XPS-ASF Replaced by XPS-AK

Differentiation

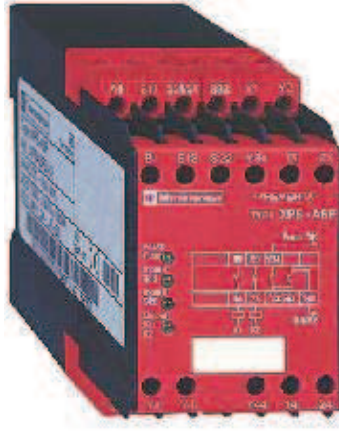
- XPS-AK has one extra N/O safety output
- XPS-AK has one extra additional N/C output
- XPS-AK has 2 extra solid state output for PLC signalling
- XPS-AK has choice of removable plug terminals
- XPS-ASF can be used for Type III A two-hand control monitoring
